TfNSW Reference: SYD23/00496/02
DPE Reference: DA 23/2901 (CNR-54185)

**PROPOSED DIGITAL ADVERTISING SIGNAGE
M2 MOTORWAY OVERPASS - WINDSOR ROAD, BAULKHAM HILLS**

Reference is made to the abovementioned development application and the Department of Planning and Environment's (DPE) correspondence of 19 June 2023 seeking comment from Transport for NSW (TfNSW) on the applicant's response to the agency's previous submission of 9 May 2023.

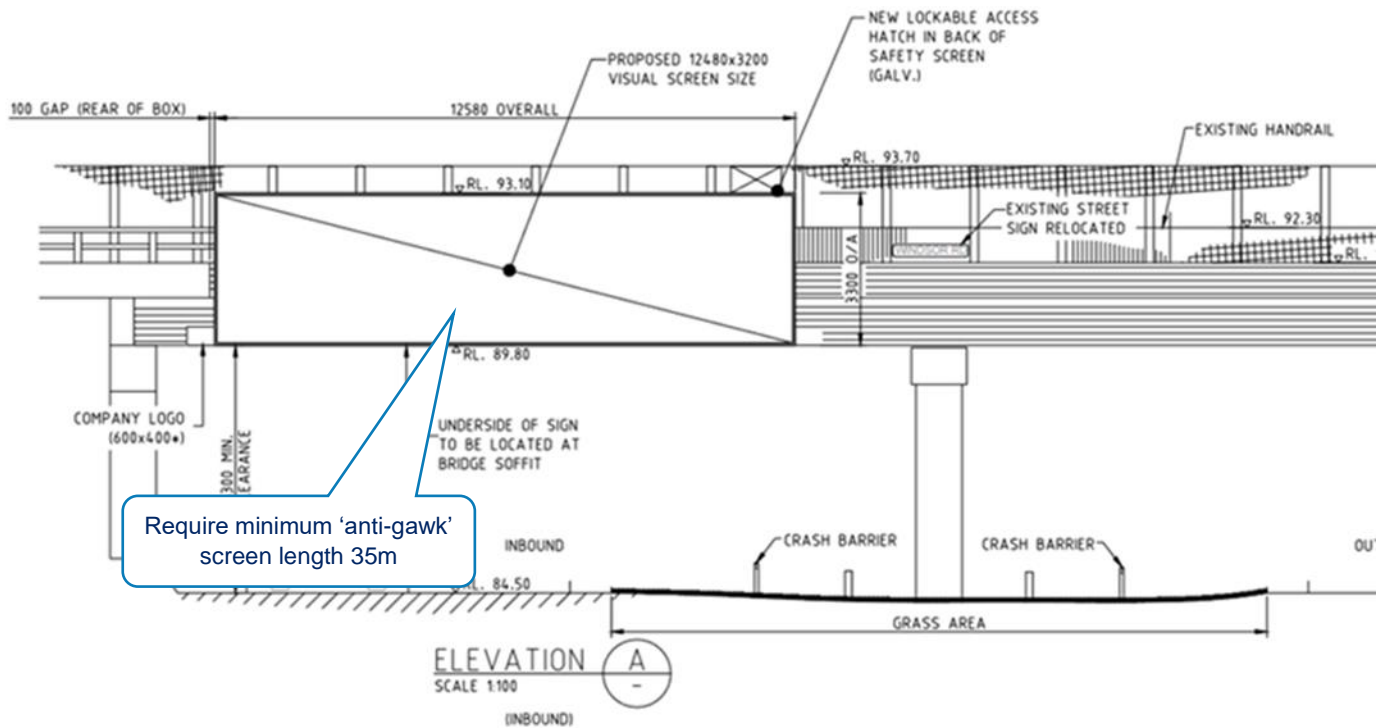
The proposed digital advertising sign extends above Windsor Road (**TAB A**) with drivers in the outside lane on the Eastbound off-ramp to Windsor Road (**TAB B**) having clear visibility to the proposed sign without having to turn their head, which has the potential to create a potential distraction at this driver decision making point (i.e. signalised intersection of Windsor Rd/M2 interchange).

To address the above potential road safety hazard, TfNSW requires the applicant to install an anti-gawk screen. Based on the absolute minimum safe stopping sight distance for a speed limit of 60km/h, the length of the anti-gawk screen shall extend a minimum of 35m west along the M2 Eastbound off-ramp approximately as depicted in **TAB C**. The height of the screen shall meet the height of the proposed digital sign but shall be confirmed by an independent Road Safety Audit.

6. The Applicant is to prepare a plan for the provision of 'anti-gawk' screens and a supplementary road safety audit is to be submitted for review and approval. The 'anti-gawk' screens are to extend a minimum of 35 metres west along the M2 Eastbound off-ramp approximately as shown in '**TAB C**' and the height is to be confirmed by an independent RSA. The applicant is to liaise with M2 Motorway regarding the physical feasibility of the proposed screens and the NSW Department of Planning and Environment regarding other required environmental approvals that may be needed.
